**GUIDANCE FOR
POST FIRE
SAFE SHUTDOWN
CIRCUIT ANALYSIS**

NEI 00-01 [Revision 2c]

DRAFT

December 2008

Figure 1-1. Deterministic Post-Fire Safe Shutdown Overview

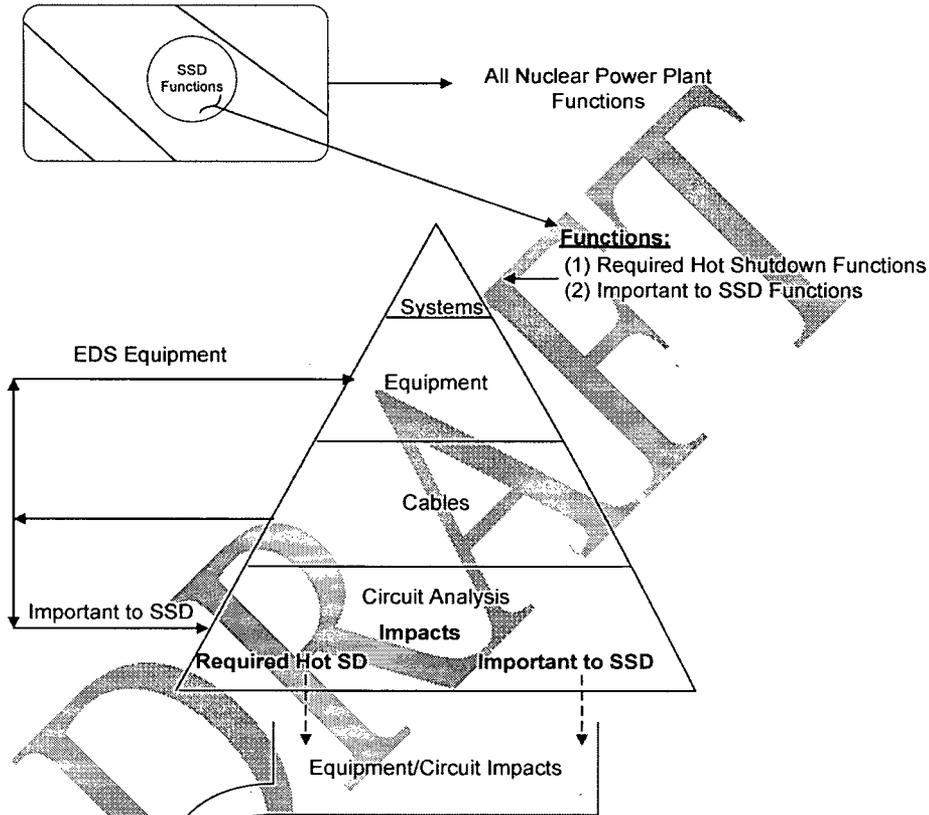
Comment [RFR16]: A flow blockage or flow diversion that could prevent safe shutdown should be designated as required for safe shutdown.

Figure 4-1 provides an overview of the MSO Identification and Treatment Process. Sections 4.3 to 4.5 below provide a description of each of the steps in the figure.

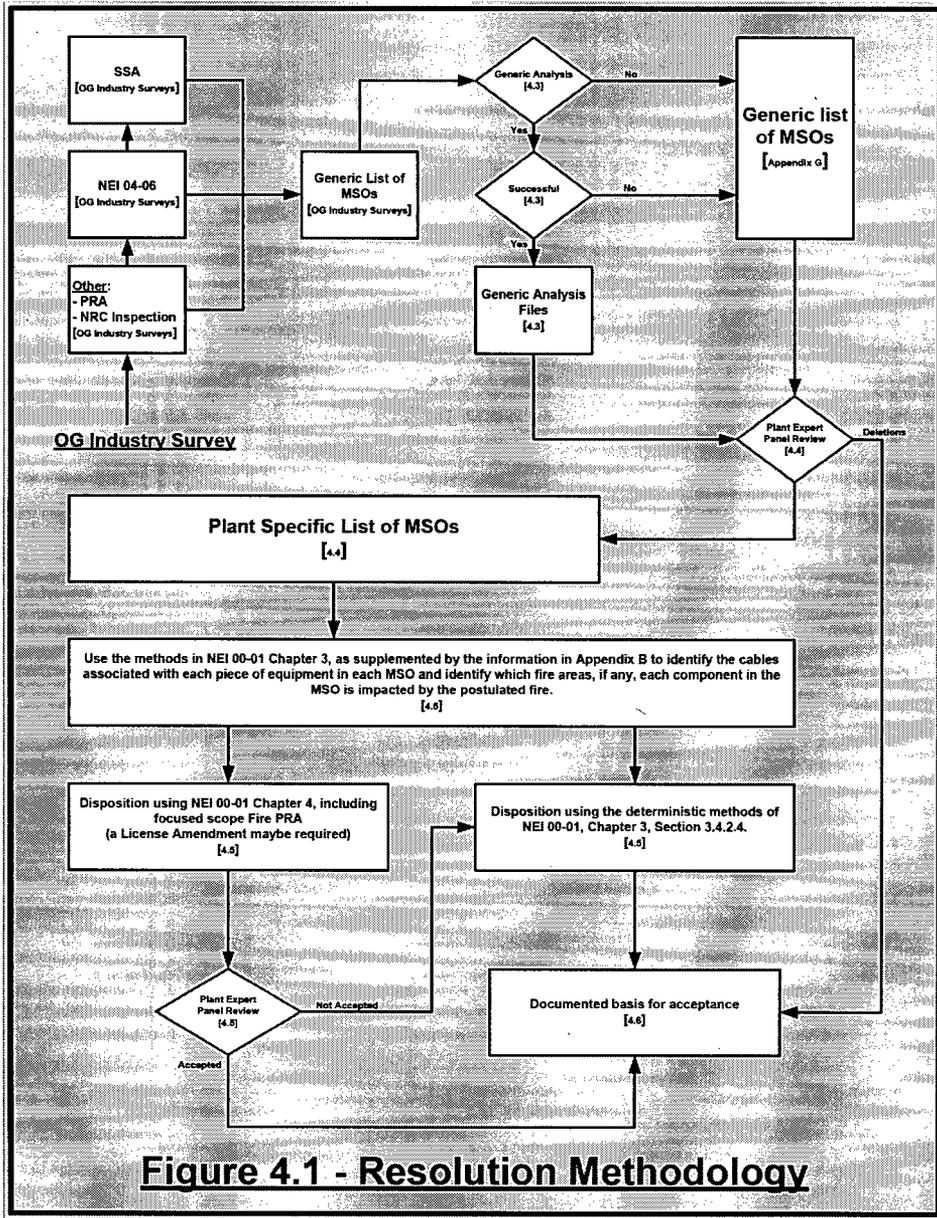
Comment [h45]: Figure changed to require LAR for focused scope Fire PRA.
